**TOWN OF HERNDON, VIRGINIA
HISTORIC DISTRICT REVIEW BOARD PUBLIC HEARING AGENDA
DECEMBER 14, 2022
HERNDON COUNCIL CHAMBERS BUILDING
765 LYNN STREET
7:00 P.M.**

Title: HDRB #22-010; Signage; 700 Lynn Street

Applicant Request	Commercial signage		
Address	700 Lynn Street		
Fairfax County Tax Map Number	0162 51 0001		
Owner	LRS Herndon LLC.		
Applicant	Natalia Velazquez, Absolute Signs		
Business/Organization	Midtown Jewelers		
Property Use	Commercial		
Zoning District	PD-TD, Planned Development – Traditional Downtown		
Adjacent Zoning	North: CC, Central Commercial District East: PD-TD, Planned Development – Traditional Downtown South: CC, Central Commercial District West: CC, Central Commercial District		
Building Type(s)	Commercial	Date of Construction:	2018
Architectural Style(s)	Traditional		
Exterior Material(s)	Brick masonry		
Neighborhood Design Profile	Downtown commercial, future development area		
Comprehensive Plan Land Use Designation	Adaptive Area

32" X 96" SIGN = 21.33 SQ FT

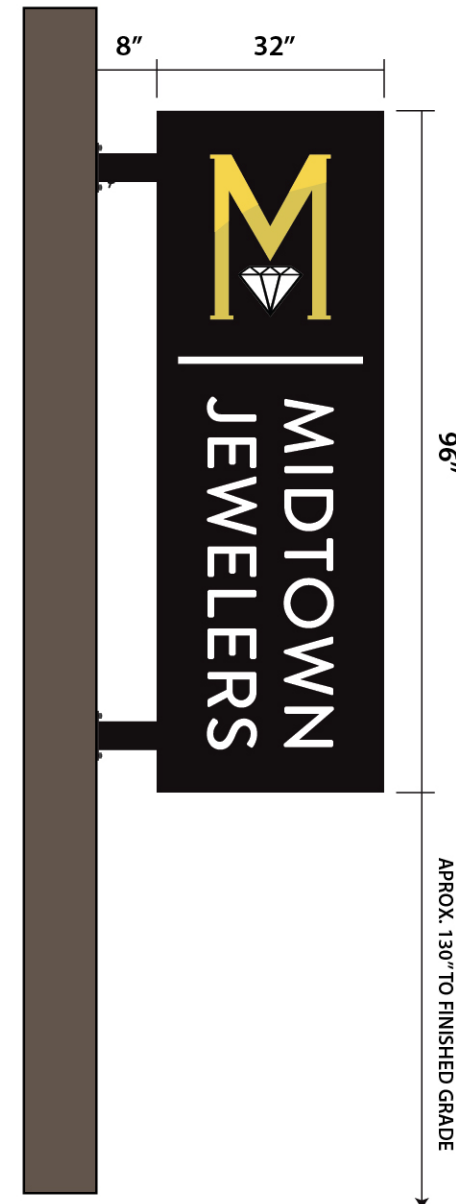
1. Staff has found that the proposed signage does not meet all the applicable standards and requirements of the Town of Herndon Zoning Ordinance:
 - a. The zoning ordinance specifies that signs in this area must be halo lit or indirectly lit. In order to qualify as halo lit, the sign face material must be

completely opaque and use a metal material rather than a plastic/vinyl/acrylic material. While the specifications for this sign include include “opaque faces”, the material for the faces is not specified to be metal.

- b. The zoning ordinance gives direction regarding how a sign must be measured: “The area of a double-faced sign shall be the area of one side only provided that the faces are either parallel or have an internal angle between its two faces of no more than 45 degrees. If one side is larger than the other the larger of the two shall be used to calculate area.” The measurements provided for this sign are for the side perpendicular to the building. Since the other face of the sign is set at an angle, it is larger and should be used when measuring the sign.

- c. Sign is placed on a logical area of the façade for a projecting sign and fits within the architectural divisions of the storefront.
 - d. The sign at 21.3 square feet exceeds the 12 square feet size recommended for blade signs however that guideline seems more aligned with traditional ground floor projecting signs and not upper story vertical blade signs. The zoning ordinance permits blade sign on upper stories to have a maximum 24 square foot size.

6. Staff is asking the applicant to address the following questions prior to a recommendation from Staff:
 - a. Size. Diminish the sign size so that it adheres to the Downtown Pattern Book cap of 12 square feet of sign face per side. As mentioned above, if there is a discrepancy in size between the two sign faces, the larger should be used to determine the size.

TOP VIEW OF PROPOSED SIGN SHAPE (APPROX):

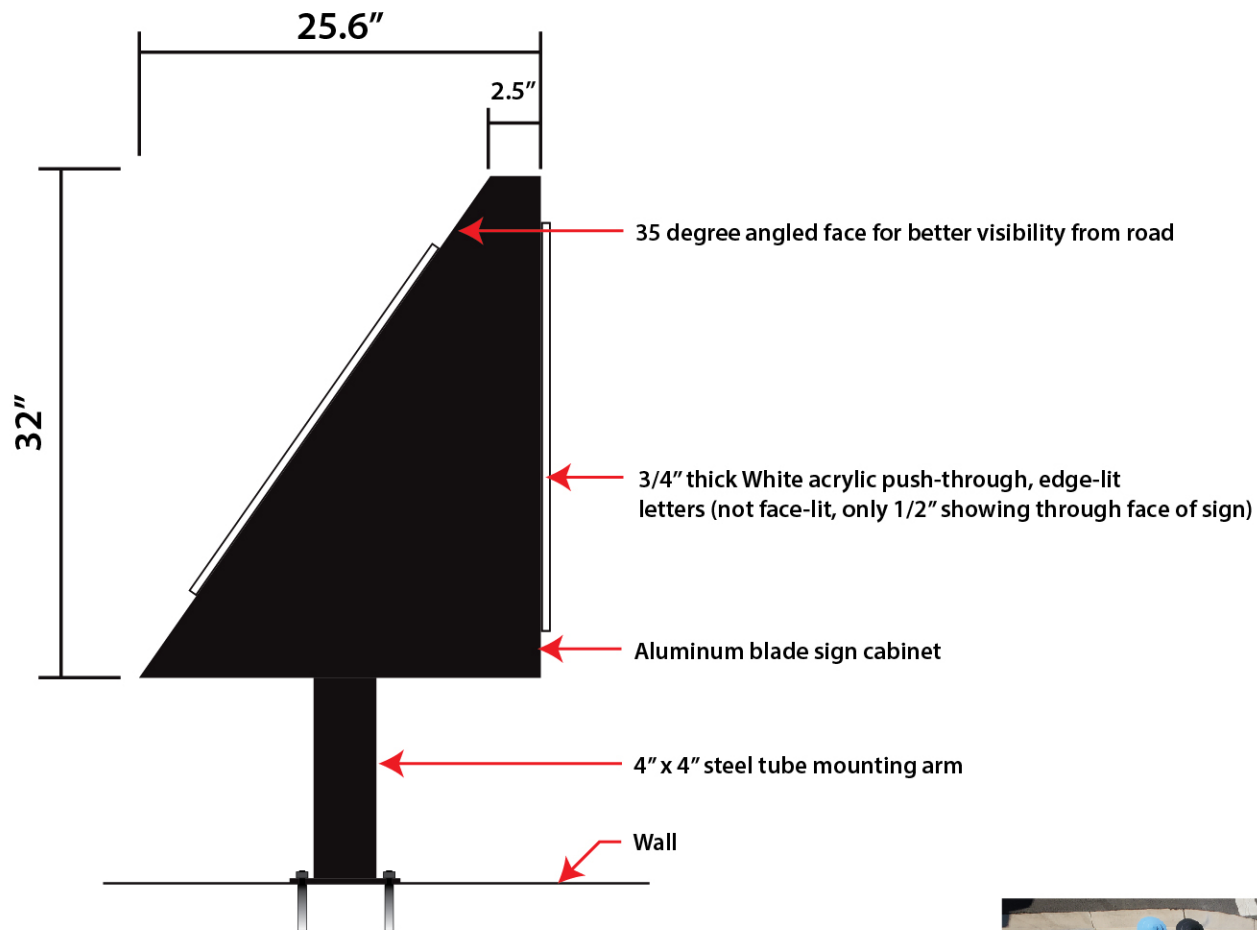
The application states that the letters consist of “3/4-inch white acrylic push-through letters and logo with opaque faces (only 1/2-inch showing through front)”. Staff has questions regarding whether the “1/2-inch showing through front” refers to 1/2-inch or translucent material or some other element of the sign.

- b. Lighting. Specify the material used to create a completely opaque sign face and sign copy as required. Clarify whether there is a 1/2-inch of the sign face that is translucent as the sign returns are.
